Work Order ID 81473

Item Name: 205 Skidtube bent detail

DRAWING NO. D2580	TITLE 205 SKIDTUBE ASSEMBLY	REV. E	DART AEROSPACE LTD ENGINEERING ORDER		D.E.O. NO. D2580-E-1	SHEET NO. SHEET 1 OF 1	SCALE NTS
DRAWN <i>UP</i>	CHECKED <i>ASS</i>	MFG. APPR. <i>EC</i>	APPROVED <i>[Signature]</i>		DE APPR. <i>[Signature]</i>		
DATE 11.12.13	DATE 11.12.13	DATE 11.12.13	DATE 11.12.13		DATE 11.12.13

CHANGE ALL C'BORED WELDED CROSSBOLT SPACERS TO SWAGED SPACERS

SECTION B-B, SECTION F-F, & SECTION I-I ARE AMENDED AS FOLLOWS
FOR ALL HOLES THAT WERE ORIGINALLY C'BORED:

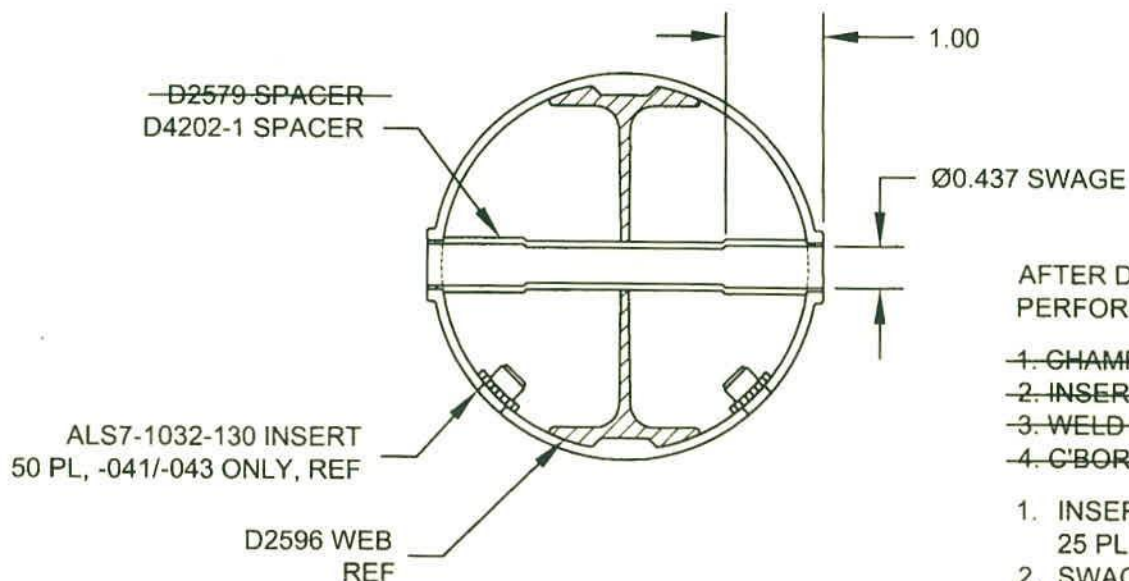
WAS

QTY	QTY	QTY	PART NUMBER	DESCRIPTION
-041	-045	-047		
20	24	25	D2579	CROSS BOLT SPACER

AFTER DRILLING AND BENDING ASSEMBLY
PERFORM THE FOLLOWING FOR Ø0.508 HOLES ONLY:

1. CHAMFER HOLE 0.050 X 45°
 2. INSERT D2579 SPACER (20 PLACES)
 3. WELD INTO PLACE AND GRIND FLUSH
 4. C'BORE D2579 SPACER TO Ø0.437 X 1.00 DEEP
1. INSERT D4202-1 SPACER, 20 PL (-041) OR 20 PL (-045) OR 25 PL (-047)
 2. SWAGE TO Ø0.437 X 1.00 DEEP PER QSI 002
 3. TRIM / GRIND FLUSH PER QSI 002

IS

4		* D2579	CROSS BOLT SPACER
20	20	25	D4202-1	SPACER

WELD 4X D2579 SPACERS PER DWG
IN LOCATIONS MARKED "NO C'BORE".
REF SHEET 4 OF DWG.
